FAYETTEVILLE PUBLIC WORKS COMMISSION

Bid Addendum

Bid Title: P.O. Hoffer Water Treatment Facility Glenville Lake Water Treatment Facility Post-Filter GAC Adsorption Facilities Contract No.67

Addendum Number: 6

ATTACHMENT NO. 3	BY DCH	GLENVILLE LAKE AND P.O. HOFFER WATER TREATMENT FACILITIES	SHEET 1 OF 1
ADDENDA NO. 006	DATE 02/2026	CITY OF FAYETTEVILLE, NORTH CAROLINA	CONTRACT NUMBER 67
		PUBLIC WORKS COMMISSION	HAZEN JOB NUMBER 30402-067
			REFER TO CONTRACT DRAWING NUMBER E204

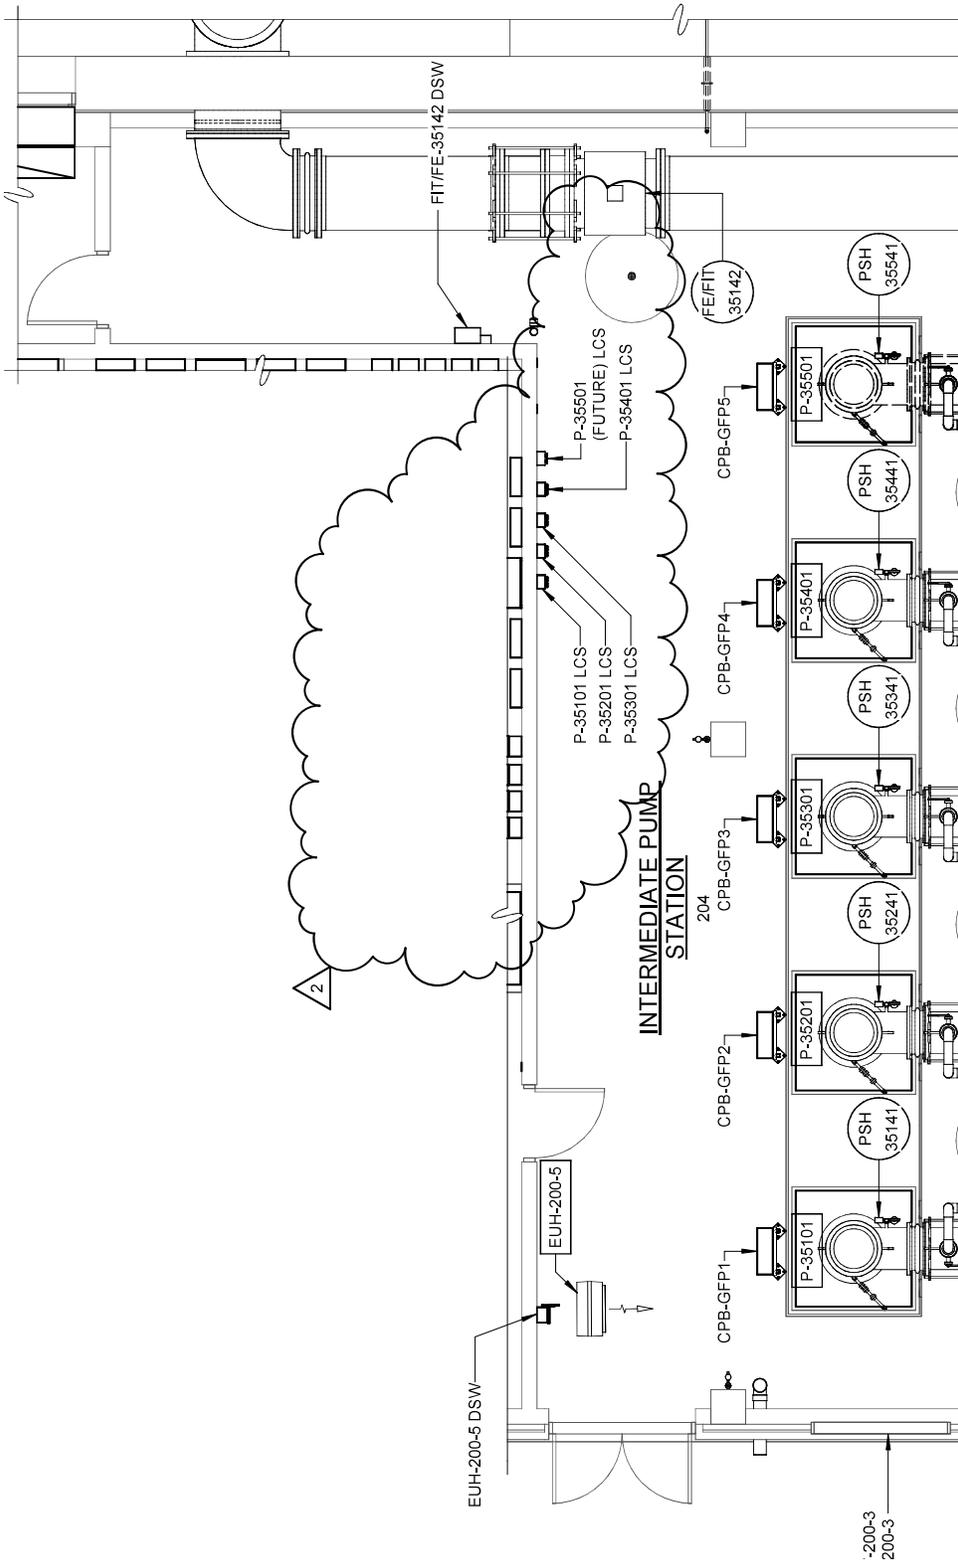
- E204 Remove pump disconnect switches and shift P-35101 LCS, P-35201, P-35301, P-35401, and P-35501 LCS South as shown in **Attachment #3**.
- E207 Revise light fixture LW5, circuit 12, VIA LC-POH-GAC2 to 36, VIA INV-POH-GAC as shown in **Attachment #4**.

ATTACHMENT NO. 6	BY DCH	GLENVILLE LAKE AND P.O. HOFFER WATER TREATMENT FACILITY	SHEET 1 OF 1
ADDENDA NO. 006	DATE 02/2026	CITY OF FAYETTEVILLE, NORTH CAROLINA	CONTRACT NUMBER 30402-067
		PUBLIC WORKS COMMISSION	HAZEN JOB NUMBER 30402-067
			REFER TO CONTRACT DRAWING NUMBER E211

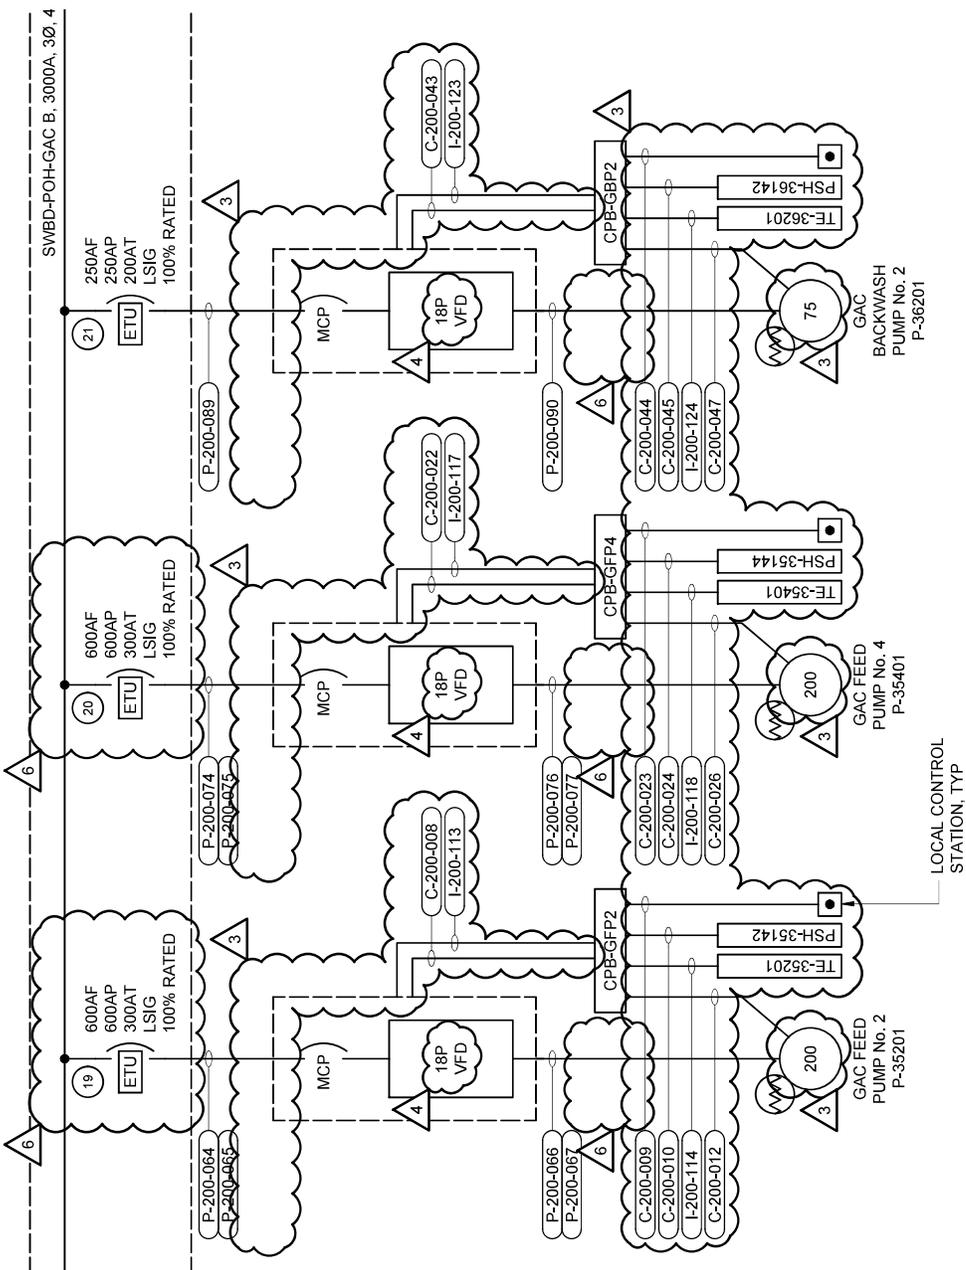
- E210 Revised pump Horsepower, breaker sizes and removed disconnect switches as shown in **Attachment #5**.
- E211 Revised pump Horsepower, breaker sizes and removed disconnect switches as shown in **Attachment #6**.

ATTACHMENT NO. 10	BY DCH	GLENVILLE LAKE AND P.O. HOFFER WATER TREATMENT FACILITY	CONTRACT NUMBER 67	SHEET 1 OF 1
ADDENDA NO. 006	DATE 02/2026	CITY OF FAYETTEVILLE, NORTH CAROLINA	HAZEN JOB NUMBER 30402-067	REFER TO CONTRACT DRAWING NUMBER E225

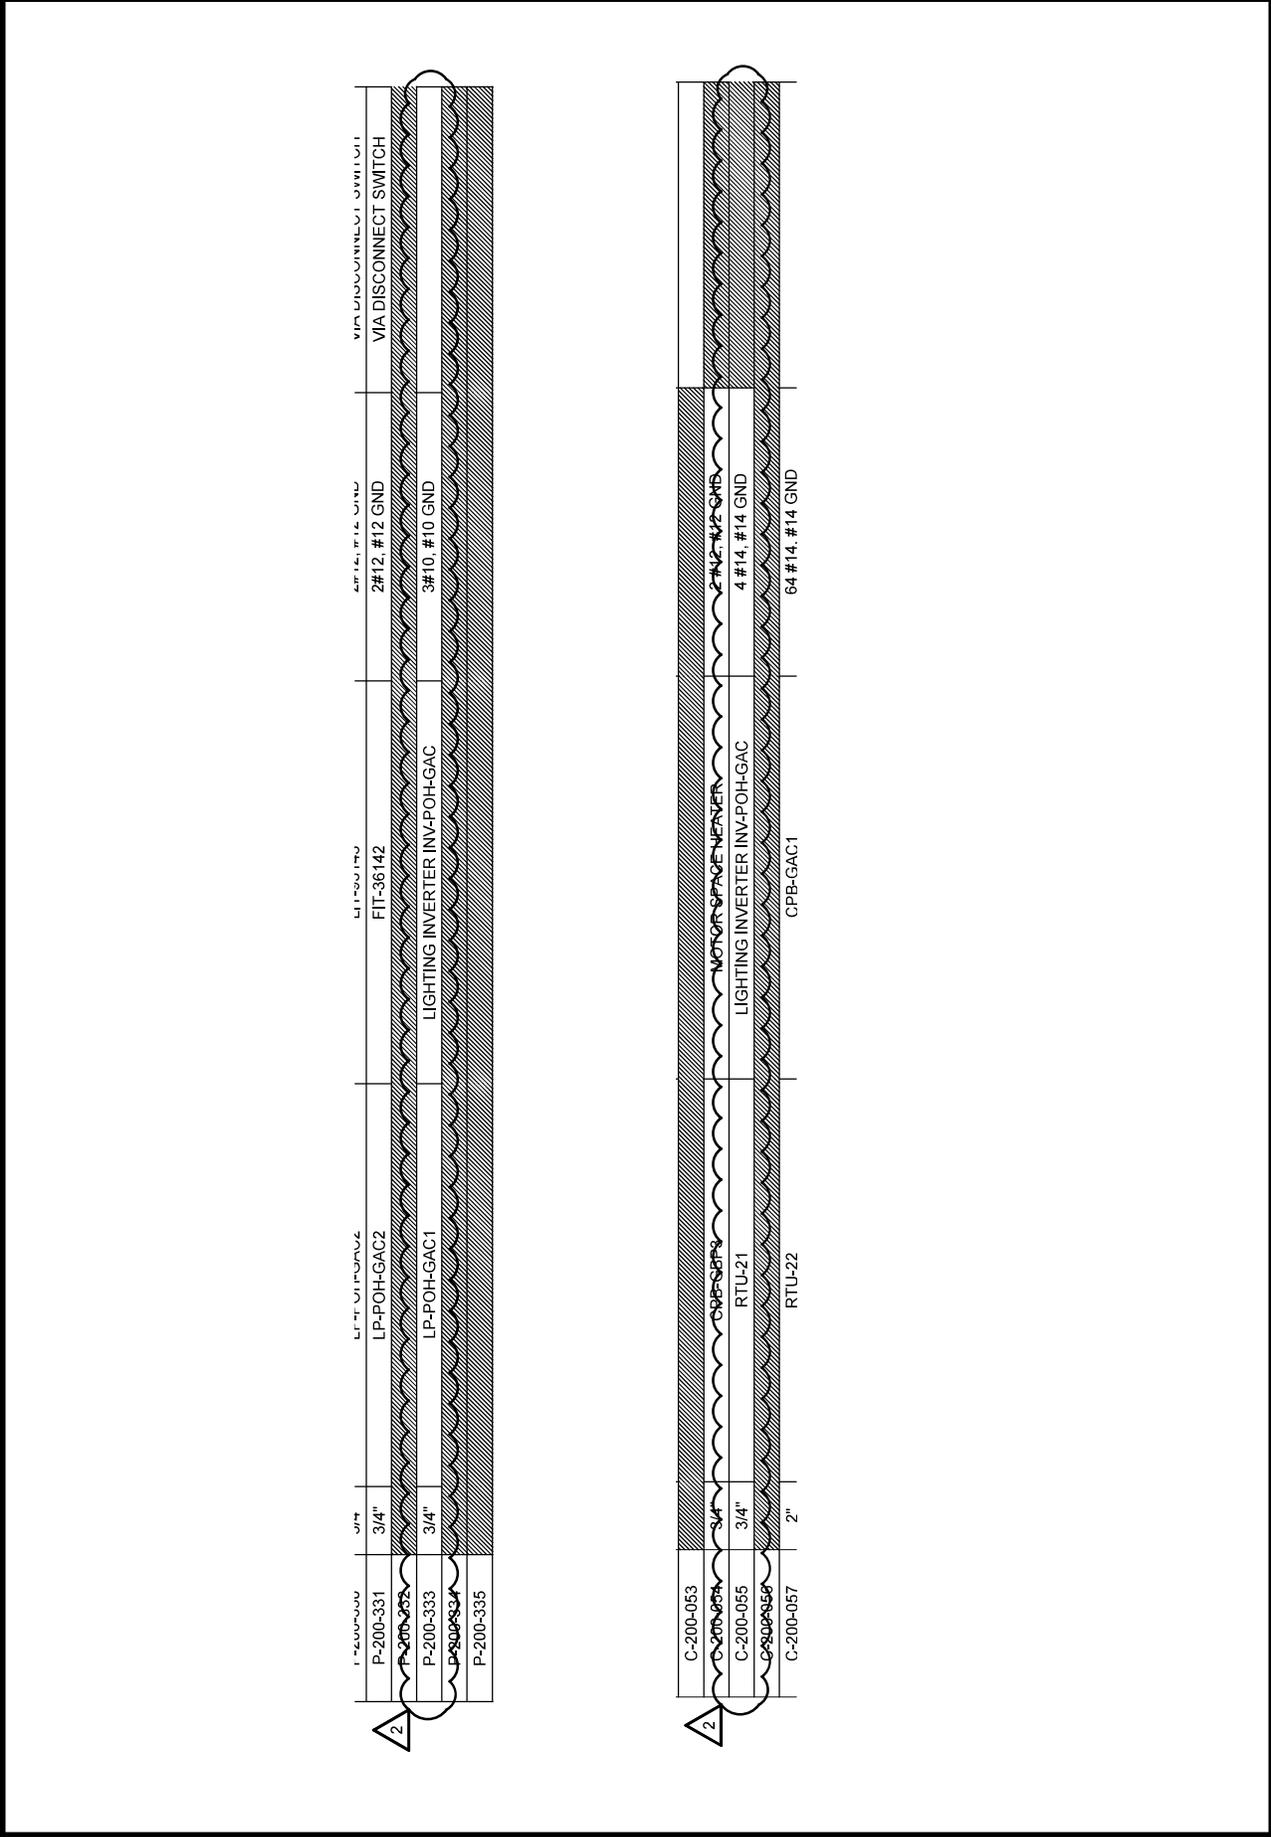
- E223 Revised conduit and wire schedules as shown in **Attachment #9**.
- E225 Revised conduit and wire schedules as shown in **Attachment #10**.
- E351 Revise "Aqua Ammonia Facility Emergency Shower/Eyewash (Outdoor)" riser diagram so that the text under FSH 56140 reads "FLOW SWITCH FOR EXIST EMERGENCY SHOWER/EYEWASH".

ATTACHMENT NO. 11	BY DCH	GLENVILLE LAKE AND P.O. HOFFER WATER TREATMENT FACILITIES	SHEET 1 OF 1
ADDENDA NO. 006	DATE 02/2026	CITY OF FAYETTEVILLE, NORTH CAROLINA	CONTRACT NUMBER 67
		PUBLIC WORKS COMMISSION	HAZEN JOB NUMBER 30402-067
			REFER TO CONTRACT DRAWING NUMBER E452

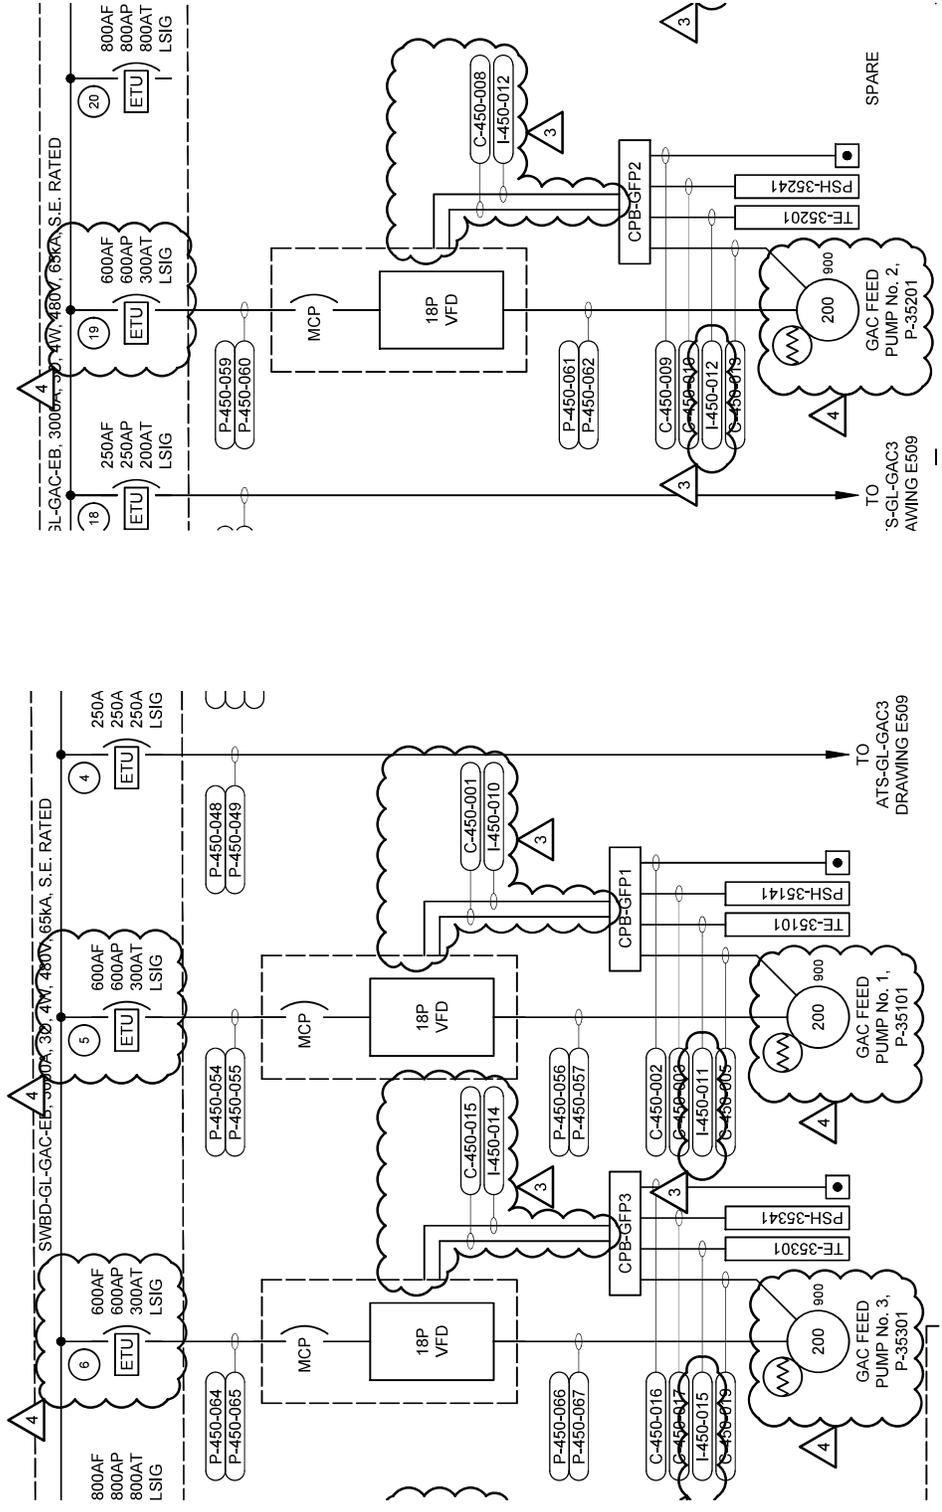
- E452 Revised pump Horsepower, breaker sizes as shown in **Attachment #11**.
- E455 Revised conduit and wire schedule as shown in **Attachment #12**.
- E502 Revise note to be legible and add note 5. "ALL LIGHTS SHOWN AS POWERED VIA THE LIGHTING INVERTER SHALL BE ON CONTINUOUSLY AS WALK-

ATTACHMENT NO. 13	BY DCH	GLENVILLE LAKE AND P.O. HOFFER WATER TREATMENT FACILITY	CONTRACT NUMBER 67	SHEET 1 OF 1
ADDENDA NO. 006	DATE 02/2026	CITY OF FAYETTEVILLE, NORTH CAROLINA	HAZEN JOB NUMBER 30402-067	REFER TO CONTRACT DRAWING NUMBER E502

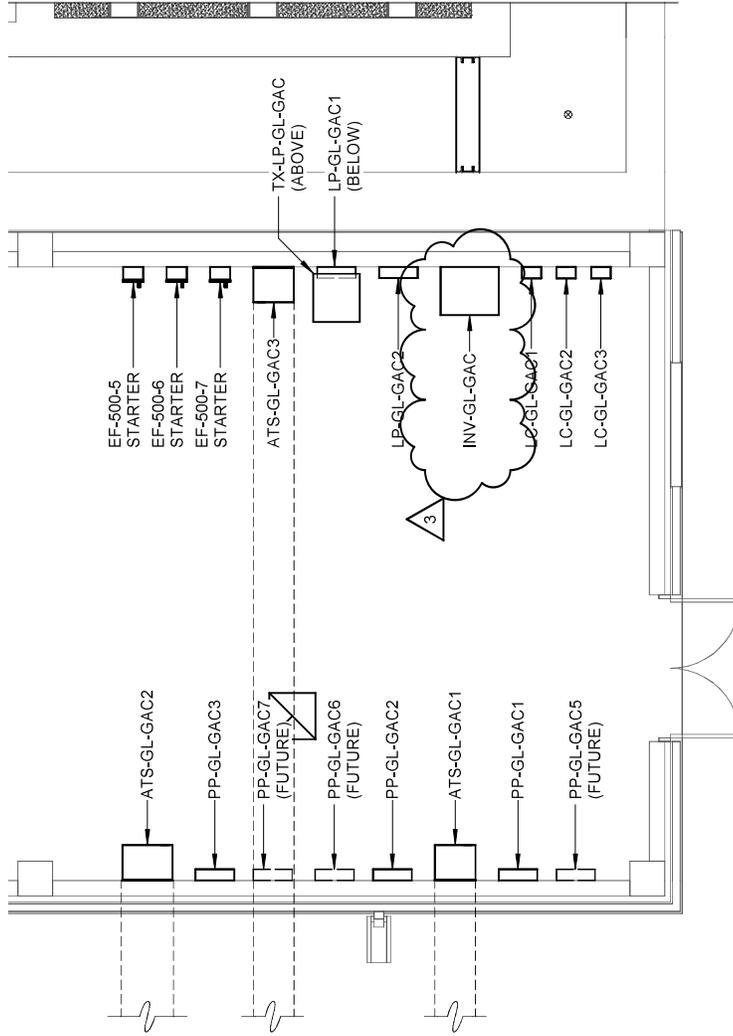
THROUGH LIGHTS. LIGHTS ARE NOT PERMITTED TO DIM WHILE ON INVERTER POWER” as shown in **Attachment #13**.

1. MOUNT FIXTURE TYPE "XW1" 6" ABOVE DOOR.
2. MOUNT FIXTURE TYPE "LP1" 12'-0" AFF.
3. MOUNT FIXTURE TYPE "LW2" 9'-0" AFF UNLESS OTHERWISE NOTED.
4. MOUNT FIXTURE TYPE "LW2" 10'-0" AFF.
5. ALL LIGHTS SHOWN AS POWERED VIA THE LIGHTING INVERTER SHALL BE ON CONTINUOUSLY AS WALK-THROUGH LIGHTS. LIGHTS ARE NOT PERMITTED TO DIM WHILE ON INVERTER POWER.

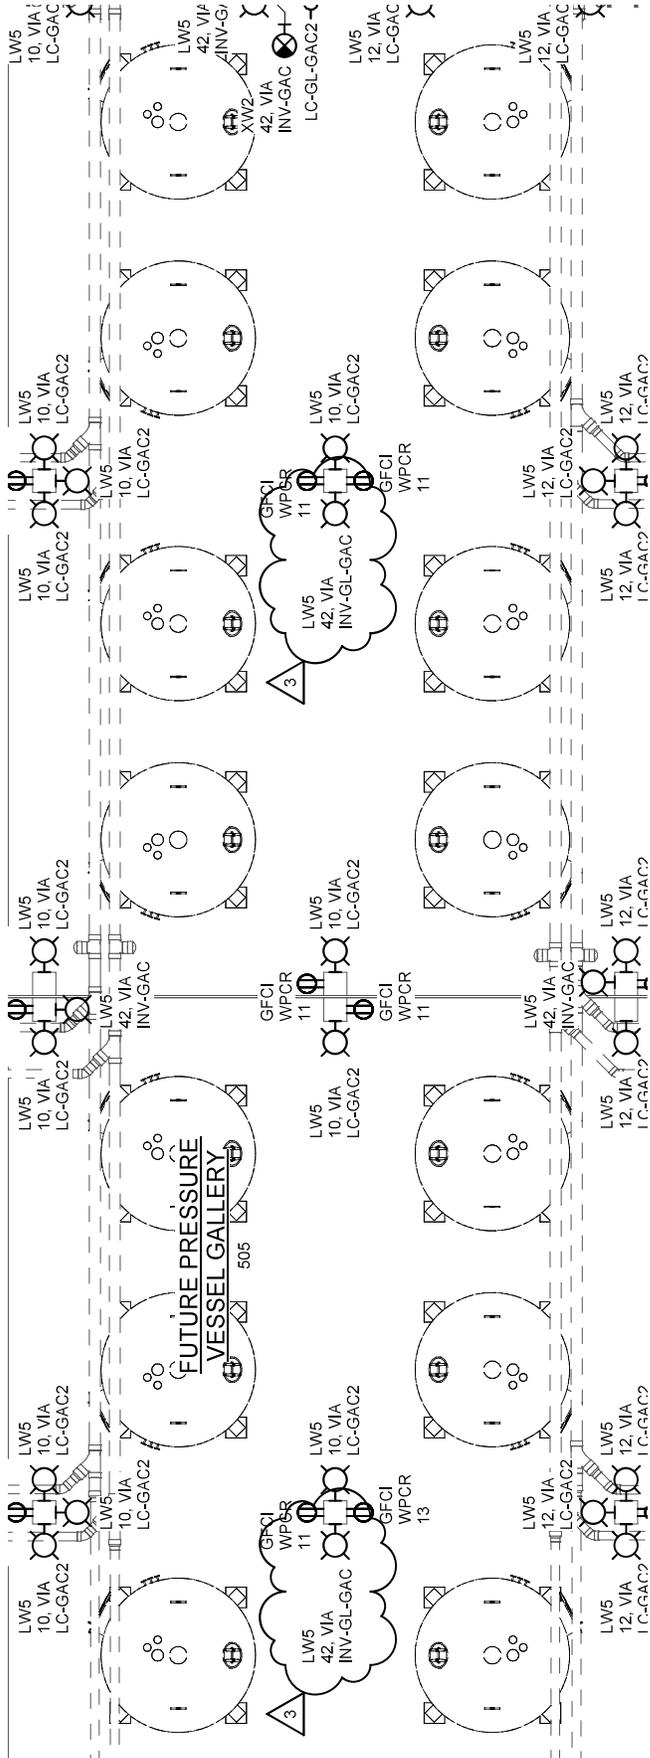
- E504 Add exit light XW2. Mount at 8'-0" AFF and connect to circuit 42, VIA INV-GL-GAC as shown in **Attachment #14**.
- E504 Revise light fixture LW5, circuit 12, VIA LC-POH-GAC2 and circuit 10, VIA LC-GL-GAC2 to 42, VIA INV-GL-GAC as shown in **Attachment #15**.
- E507 Added Lighting Inverter INV-GL-GAC riser diagram as shown in **Attachment #16**.
- E508 Revise panel schedule PANEL LP-GL-GAC2 as shown in **Attachment #17**.
- E508 Revised conduit and wire schedule as shown in **Attachment #18**.
- E508 Revised conduit and wire schedule as shown in **Attachment #19**.
